Car Stereo  
Service Bulletin

**Model:** CDX-5180

**No.248**

**Subject:** Ticking Noise During Quiet Passages Or  
Between Tracks On Disc

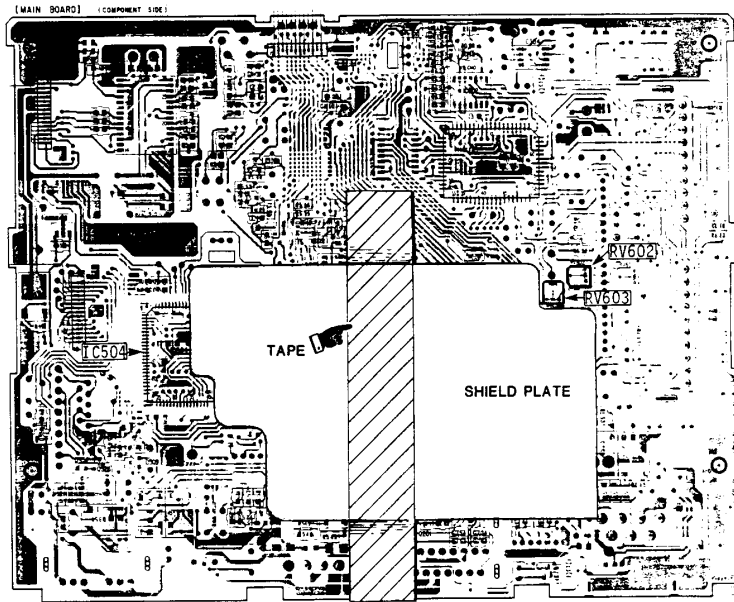
**Symptom:**  
(54)

A ticking noise may be heard from the speakers while listening to quiet passages on the disc, or when between tracks.

Add a shield plate to the Main Board as shown below. Secure the shield with tape:

DESCRIPTION	PART NUMBER
SHIELD PLATE	T-9985-491-1
